Product Change Notification (PCN)

Date: 31 October 2025

Subject: GBLG2 motor drive series plastic cover change

Old STO Opening

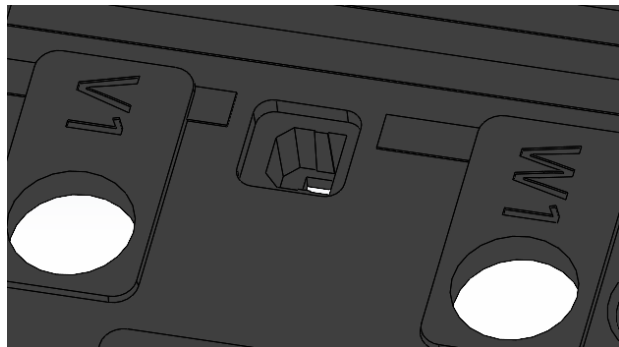
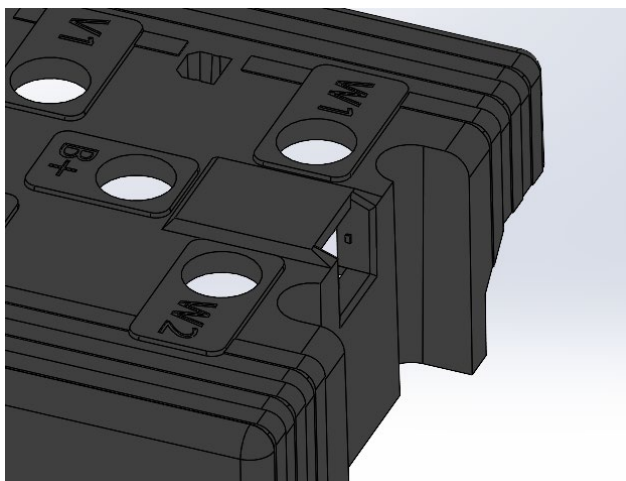
- **Type of Change:** Product Specification
- **Detailed Description:** The plastic cover of the GBLG2 motor drive families has been modified. Specifically, changes were made to the STO opening and the Ethernet PCBA extrusion feature.

- **Reason for Change:** For the STO opening, a rubber cap was added to improve sealing and protection. The updated design includes a recess, as shown in the new images, allowing the rubber cap to sit flush with the rest of the cover.
